**CITY OF SAN ANGELO  
BELL STREET PAVING, WATER AND WASTEWATER IMPROVEMENTS ALL PHASES  
SAN16188**

**ADDENDUM NO. 1**

**December 21, 2017**

**00 91 13      ADDENDUM NUMBER 001**

SHEET		W-15	
SEQ.		79

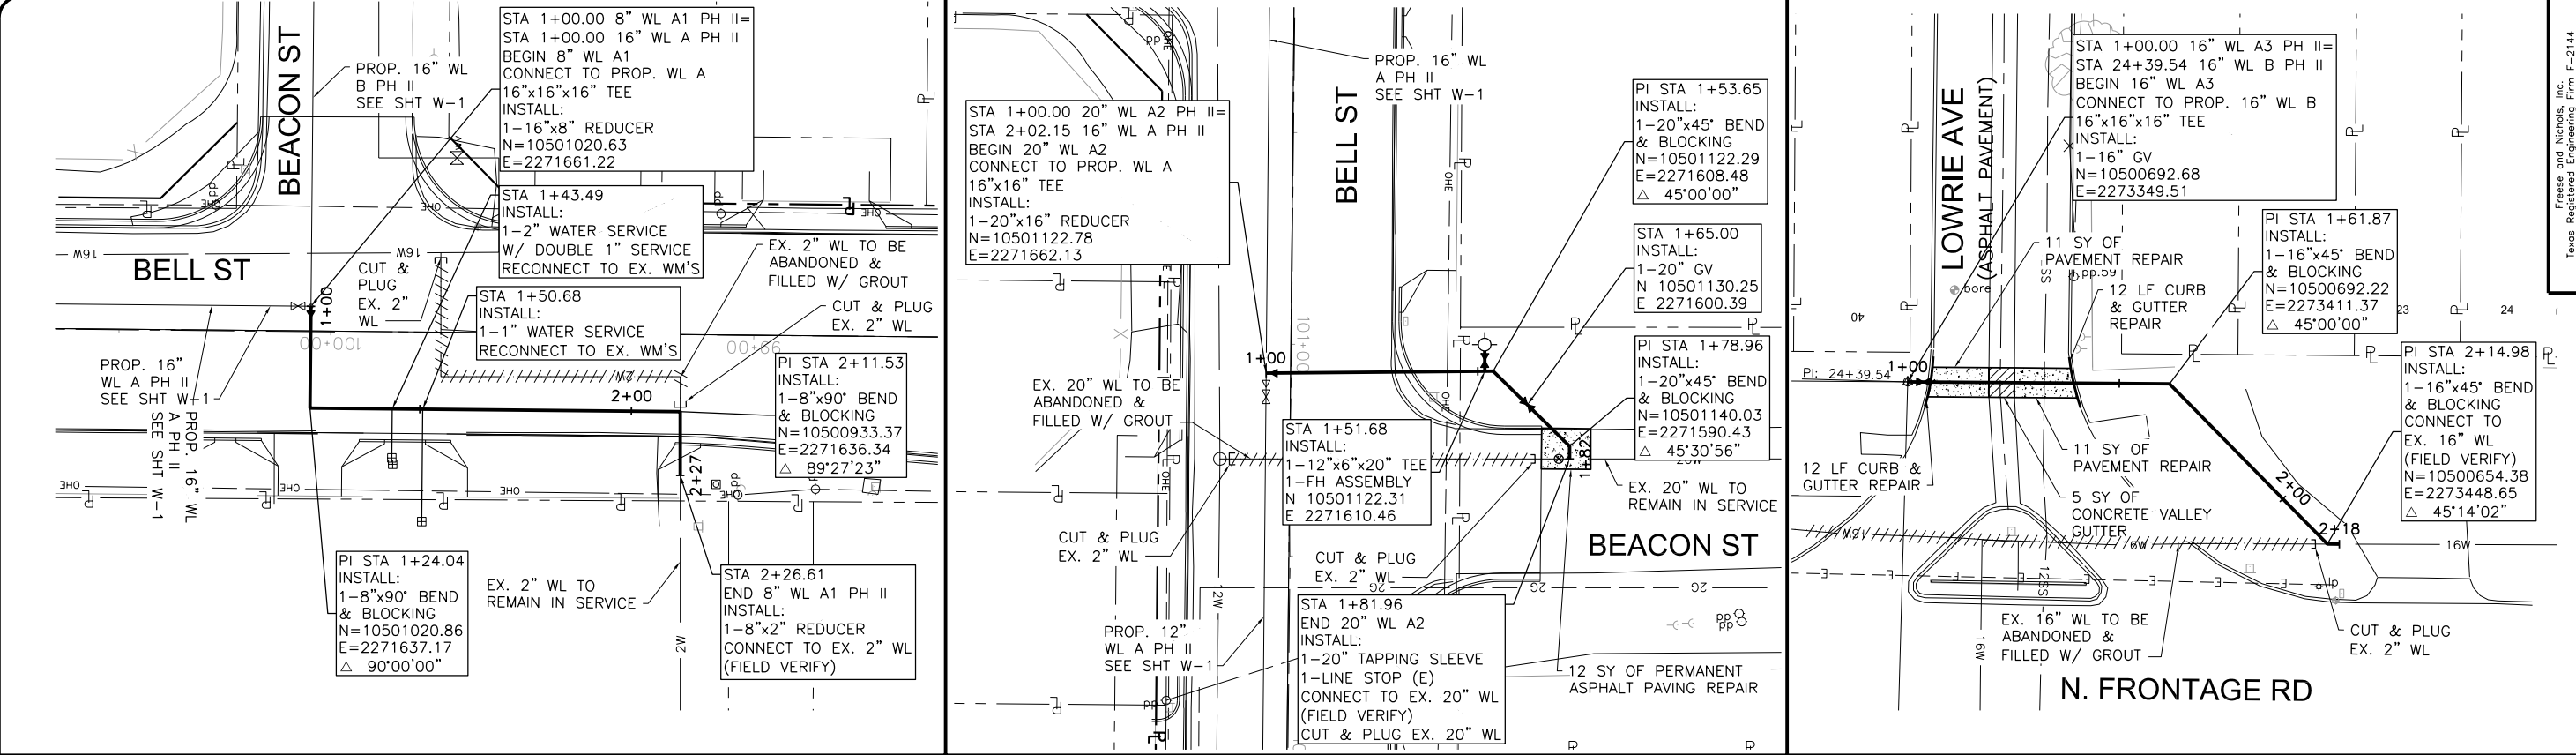
Project:	Bell Street Paving, Water, and Wastewater Improvements - All Phases	FNI Project No: SAN16188	Last Updated: 12/21/2017
22	Phase II-Water;  Plan sheet W 15 — Sta 42+50 — Shows a 12x2x12 tee. This should be a 16x2x16 tee correct? Would you allow a service saddle verses a fitting instead?	Yes. FNI will update the drawing to show 16"x2"x16" tee at STA 42+50.00 in Phase II Sheet W-15. FNIwill allow a service saddle.	Refer to Addendum 01, Updated Drawings, Phase II Sheet W-15.
23	Phase II-Water;  Plan sheet W 7 Sta. 1+20 can you explain this tie in ? We have two 16 inch lines your tying in with a 12 inch line is this because you don't want to tap the line same size as line diameter?	That is correct. Also, this is a temporary connection as the line will connect to the proposed line but due to trying not to limit construction seuencing we are showing this tie-in to the existing line.	None
24	Phase II-Water;  Plan sheet W 16 — Sta 1+78.96 the tap you show on the 20 inch line can you tell me if it's concrete cylinder or ductile pipe?	It is our understanding that this is concrete cylinder pipe but it is the Contractor's responsibility to field verify exact location and pipe type.	None

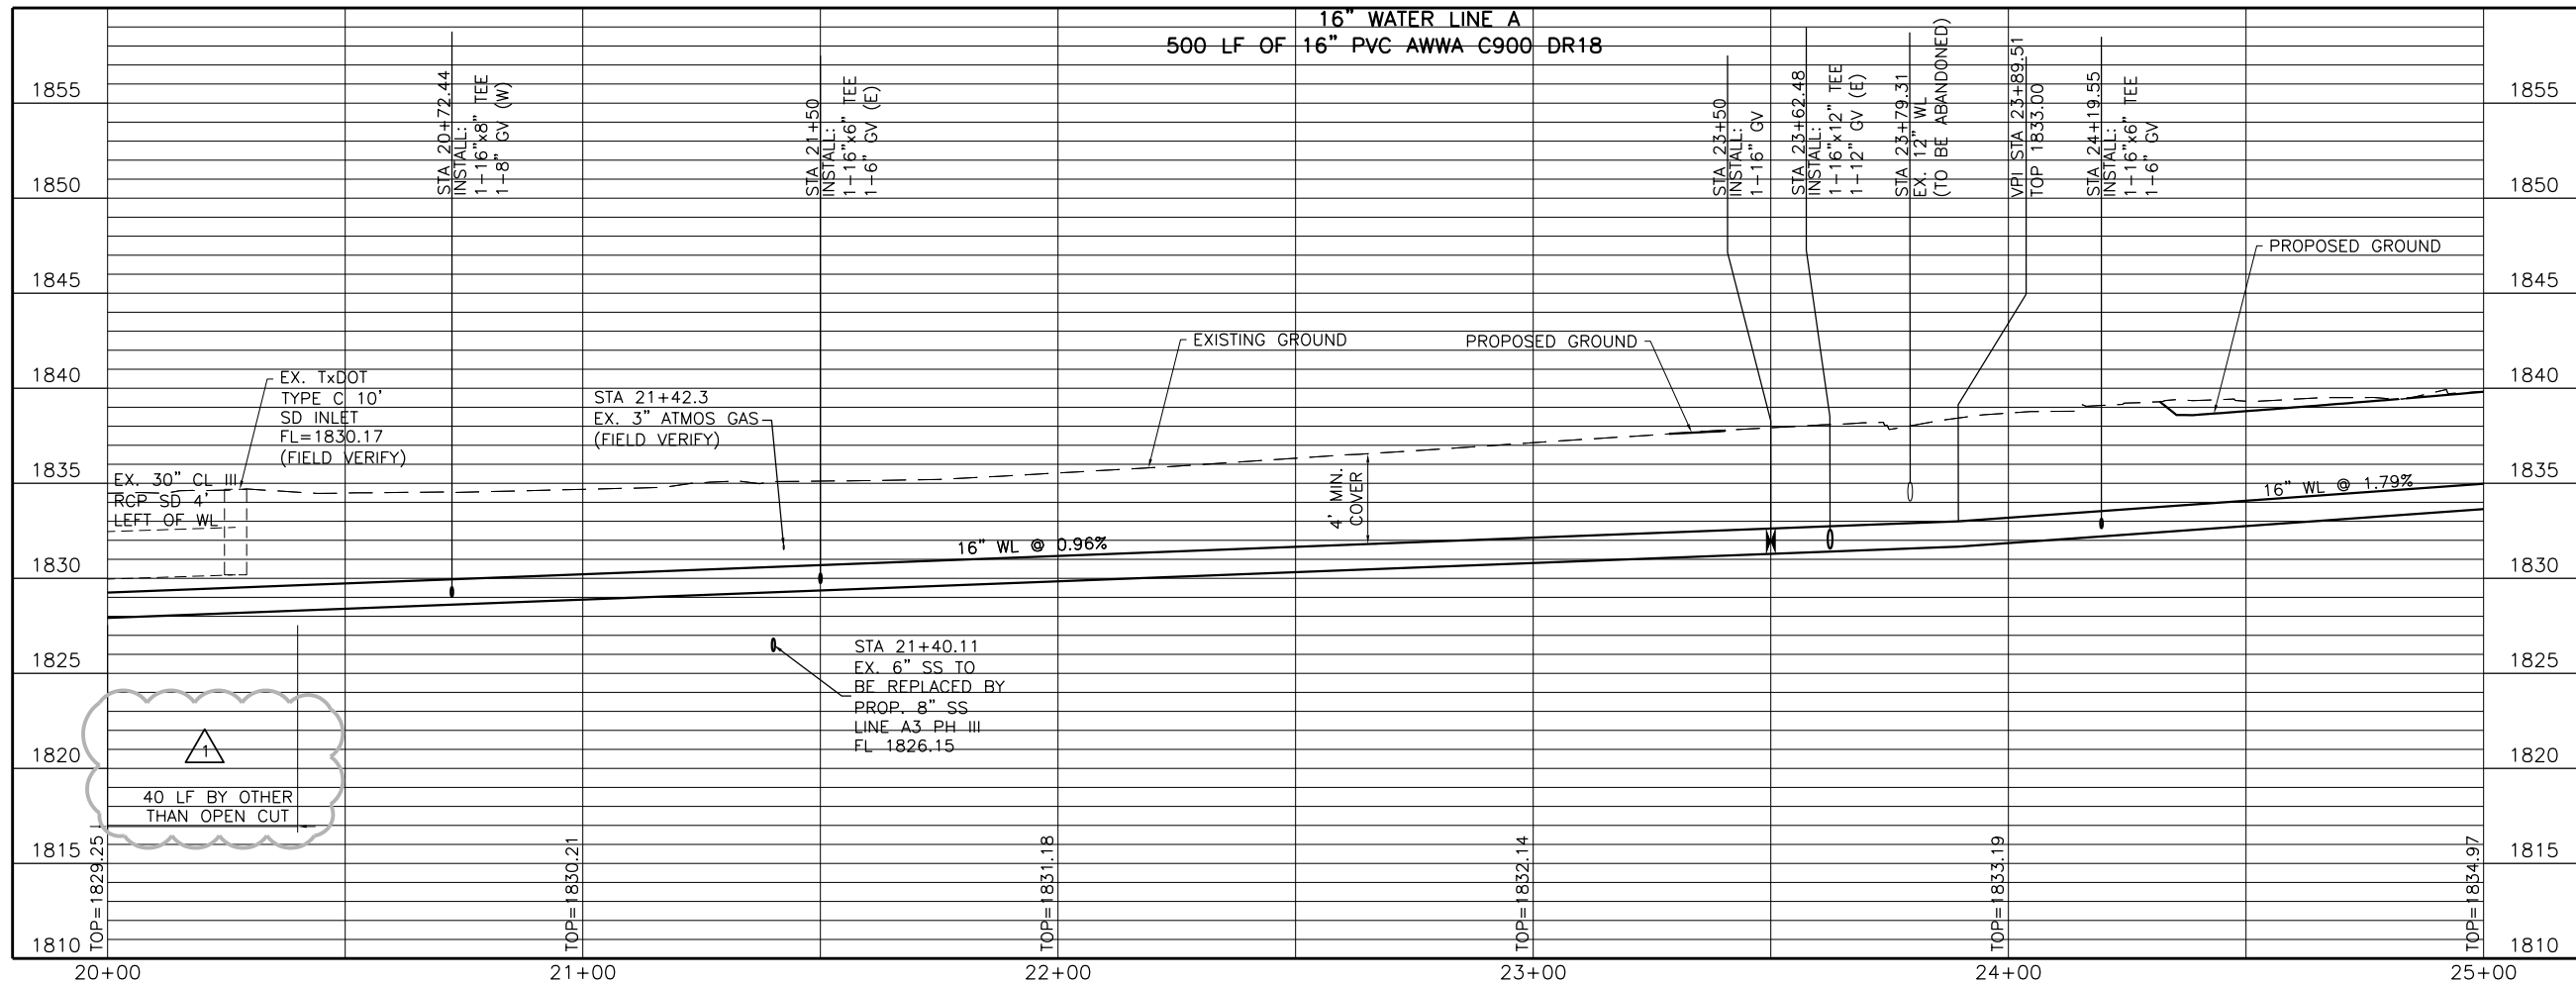
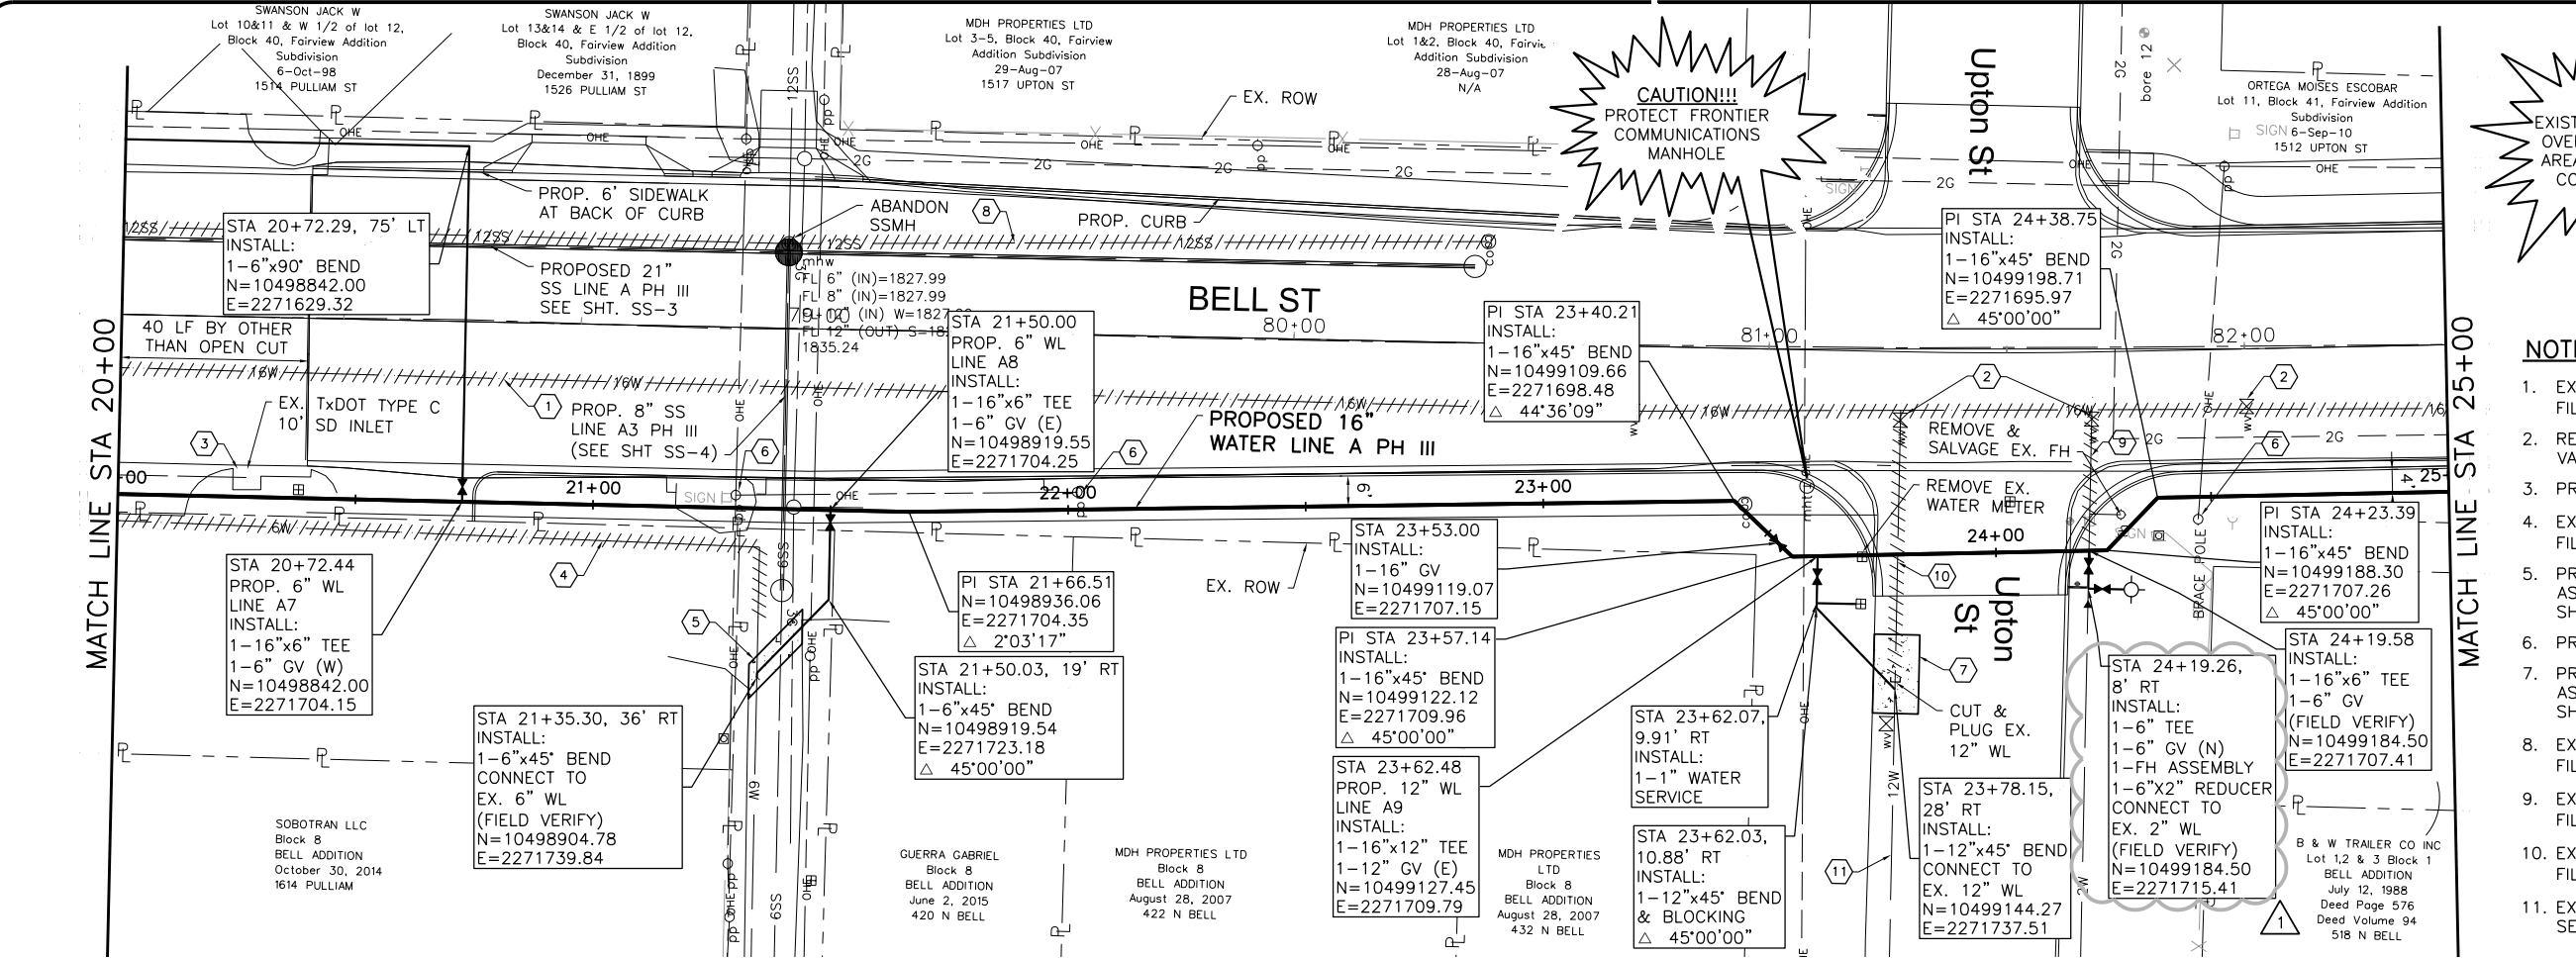
14	Waterline Alignment;  Contractor is also concerned about the tight tolerances between existing utilities and new installations-Particularly near Rio Concho.	After internal discussion and review with FNI’s Construction Services team, it has been determined that it is possible to install the water main as shown in the plans that were issued for Bid.	None			
15	Waterline Alignment;  Contractor wishes to move towards the center/other side of street to save some curb removal (Phase II Sht W10).	The waterline alignment will remain as shown on the plans that were issued for Bid.	None			
16	Phase III Water Construction;  Sheet W 5 - Sta 24+19.26 The plan sheet shows a 12 inch 45 degree bend. We are reducing from 6 inch down to two inch water connection what is the 12 inch bend for?	Sheet W-5 has been updated to correct this call out at STA 24+19.26.	Refer to Addendum 01, Updated Drawings, Phase III Sheet W-5.
